## Comments for Oregon Solar Energy Code

David McClelland

Energy Trust of Oregon

**Figure 1.**

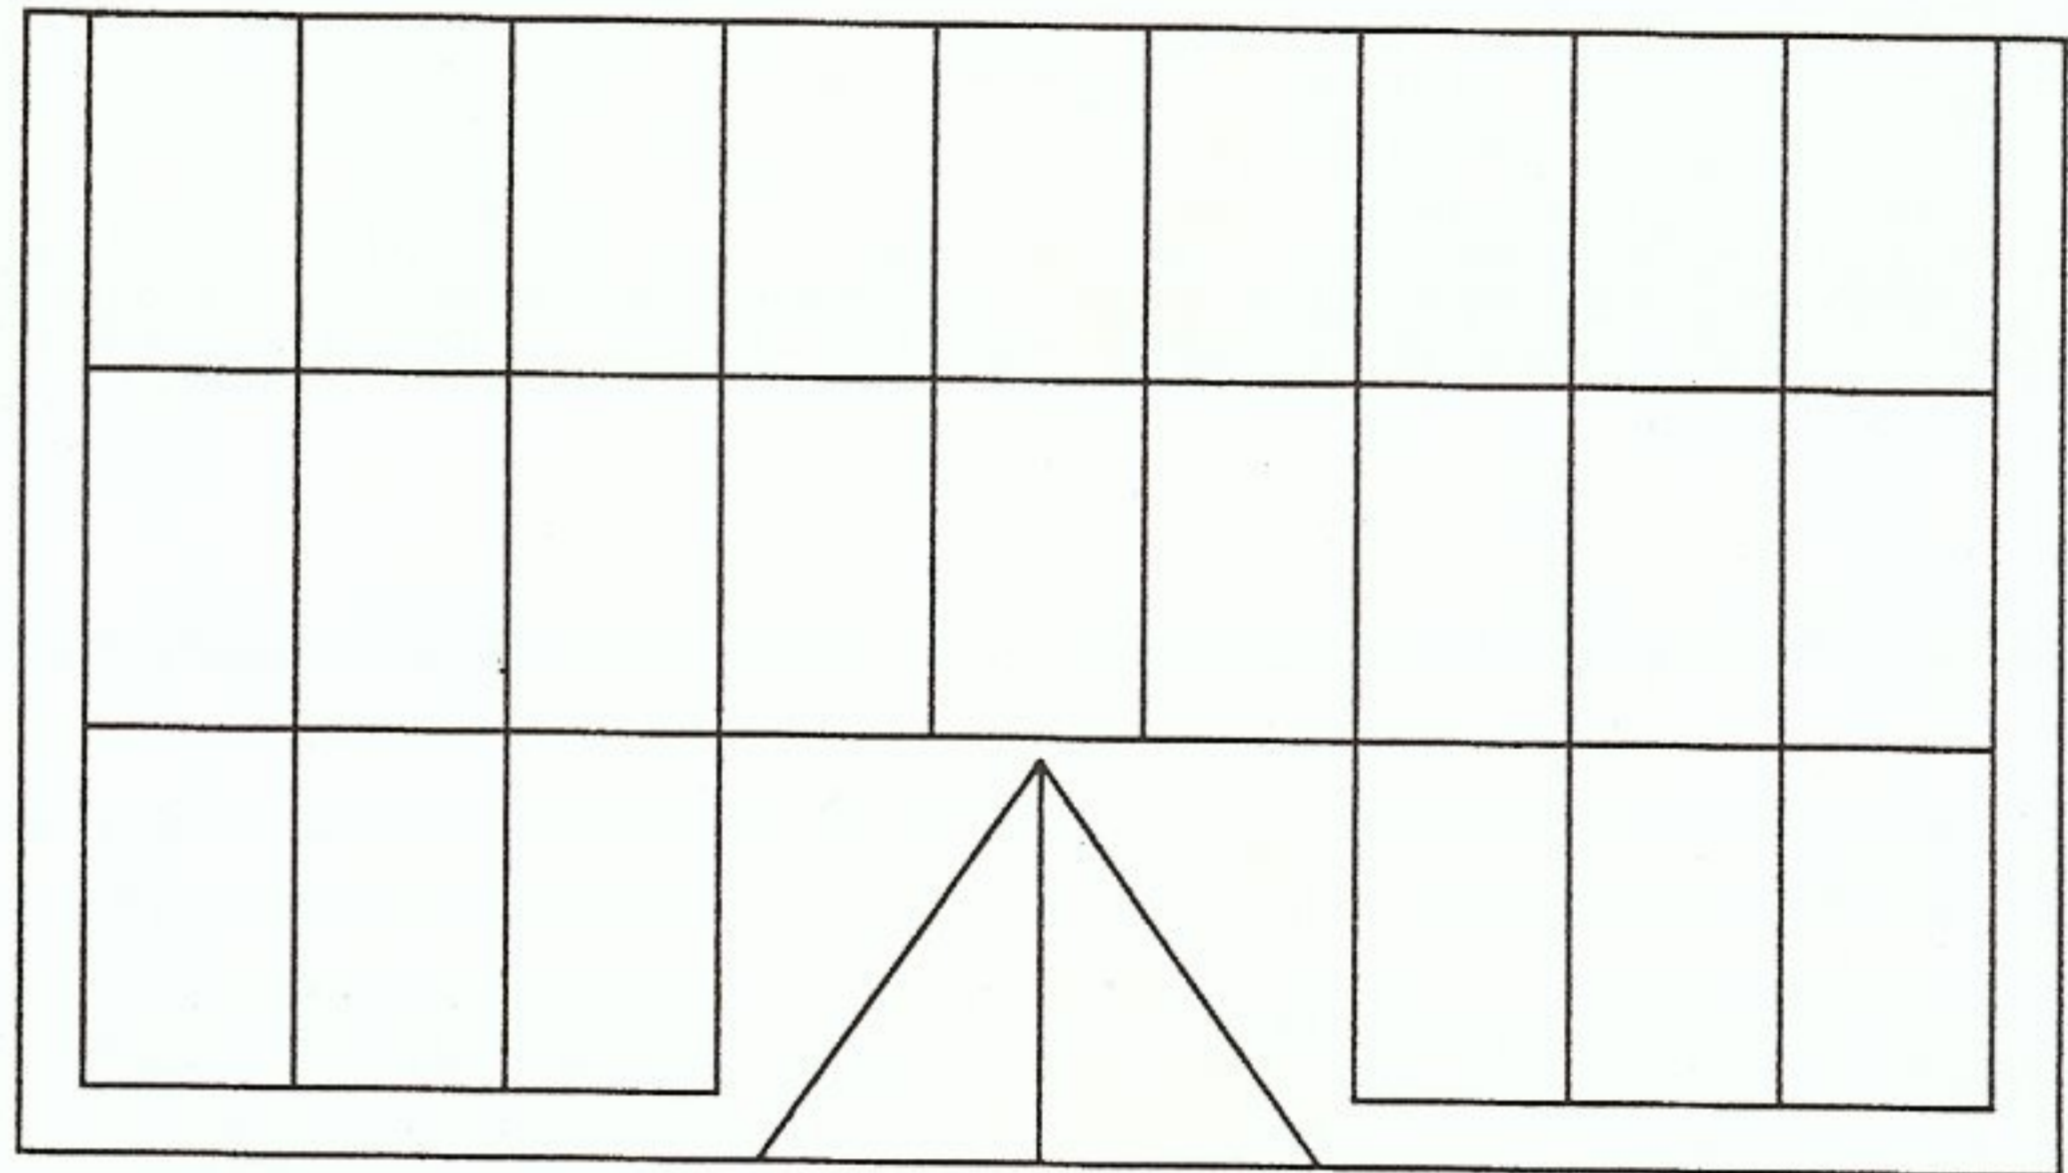
System setback requirements have a disproportionate impact on residential installers working with roof space that is already limited by orientation, shading, and building structure (gables, chimneys, vents).

Example: small home with 30' x 17' south-facing roof.

Maximum potential capacity without setback:

**5.5 kW**

**Figure 2.**

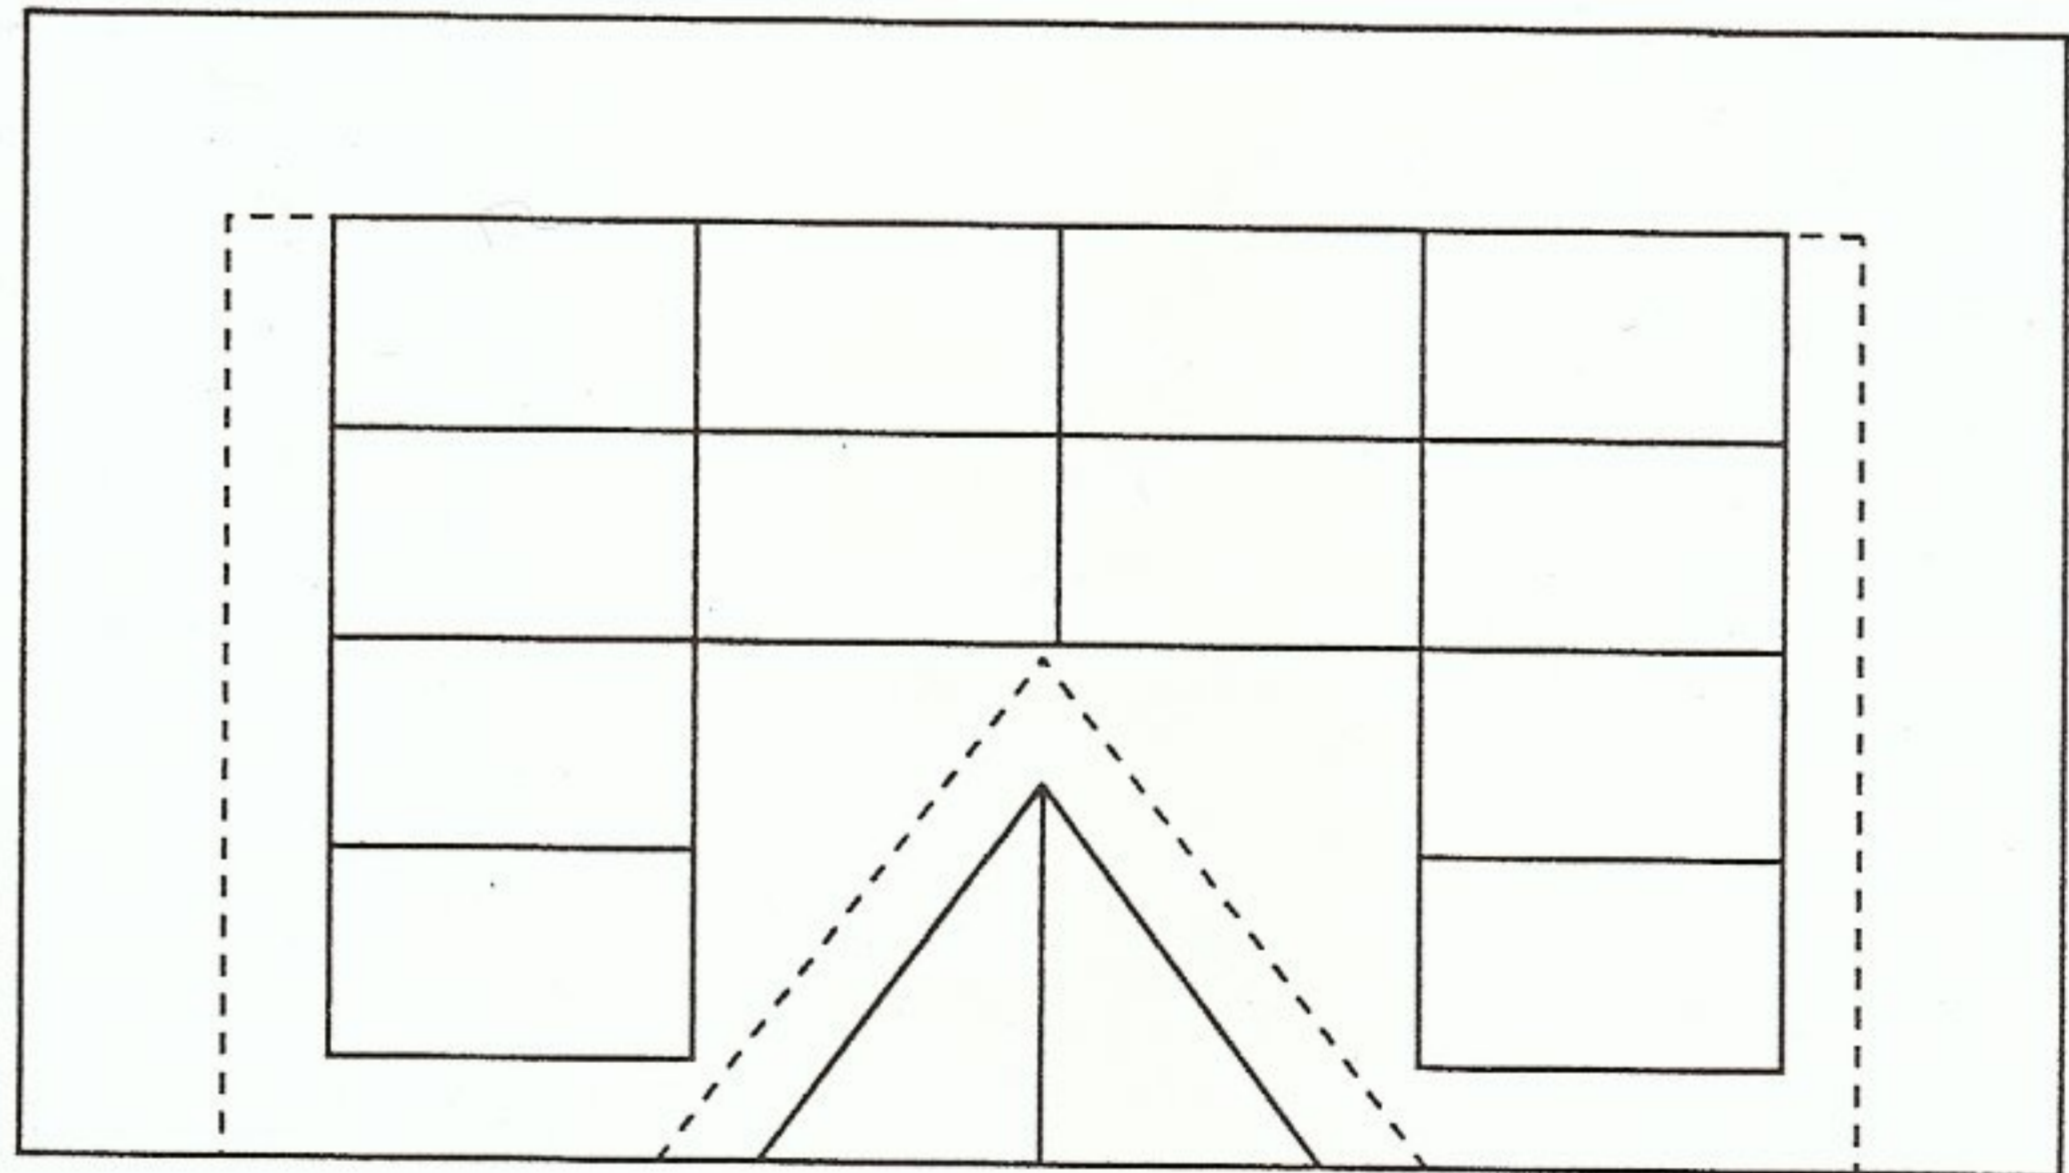
With proposed 3' setback:

**2.5 kW**

*55% reduction in output*

**Figure 3.**

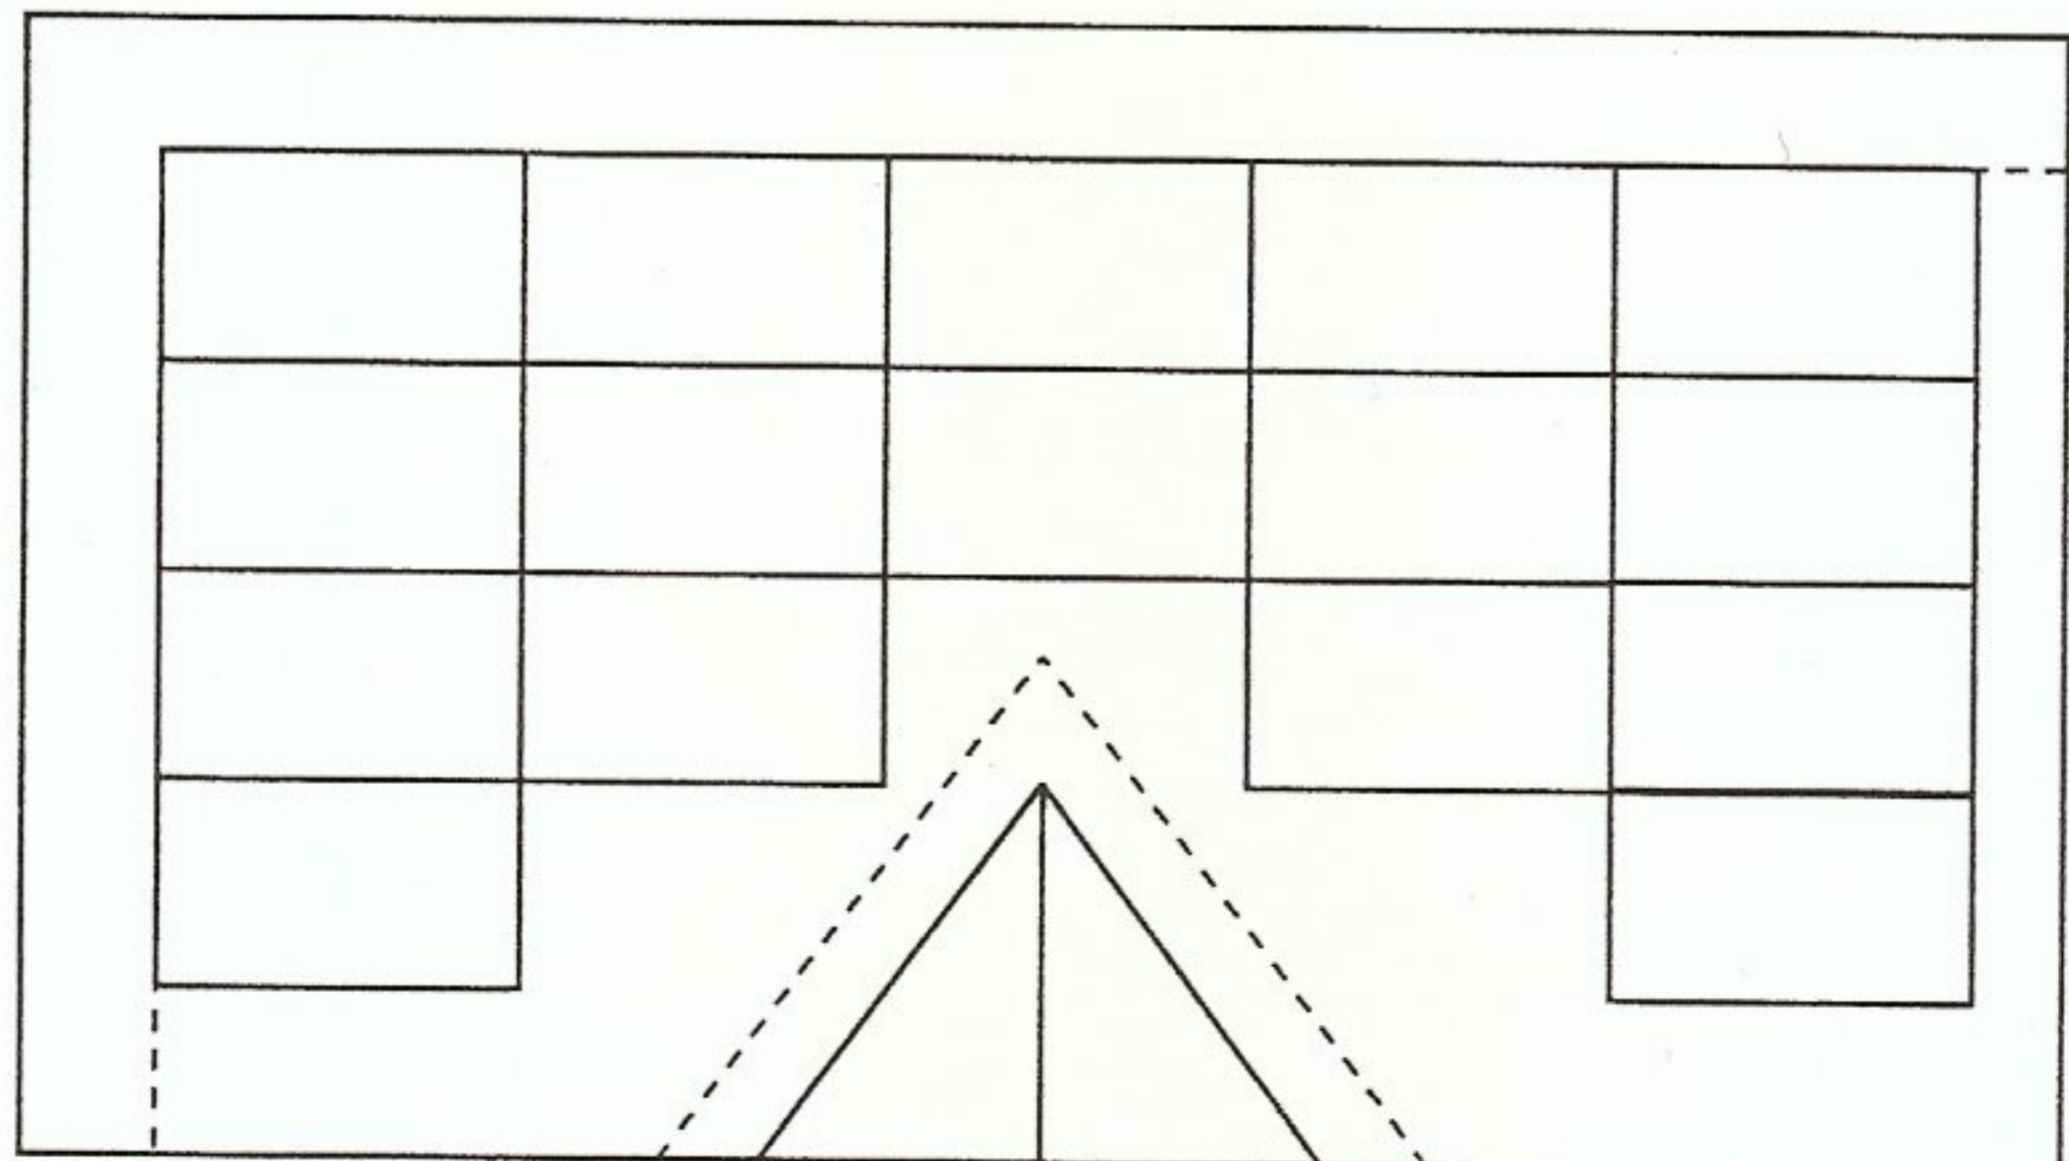
With 2' setback from ridgeline and one edge:

**3.7 kW**

*33% reduction in output*

**Figure 4.**  
2 kW system with tree shading on lower half of roof.

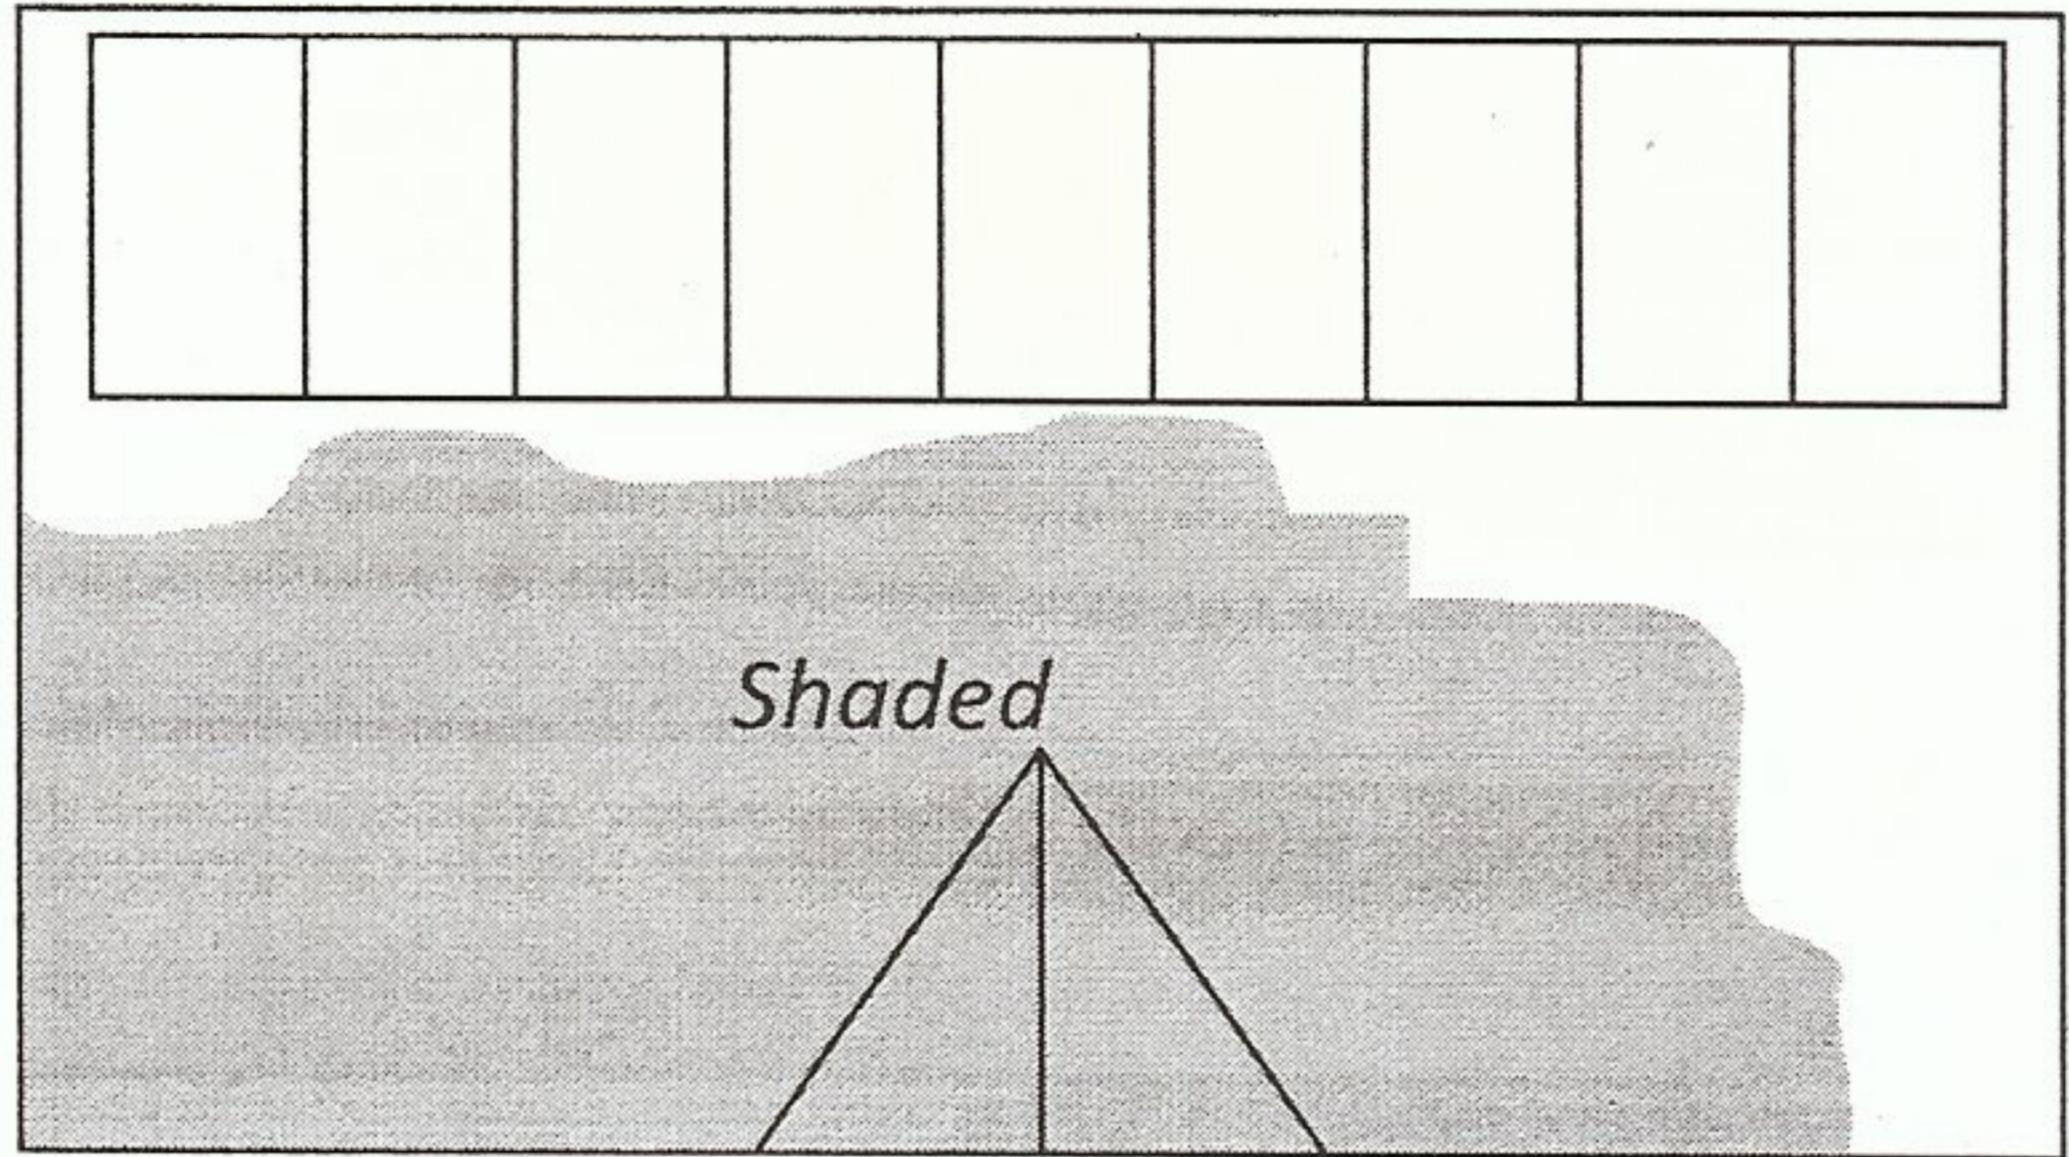
Even for small systems—where the majority of the roof remains uncovered and accessible—setbacks limit design options that allow installers to minimize shading impacts and maximize performance. Under the new feed-in tariff incentive structure, performance is critical to the customer’s payback on investment.
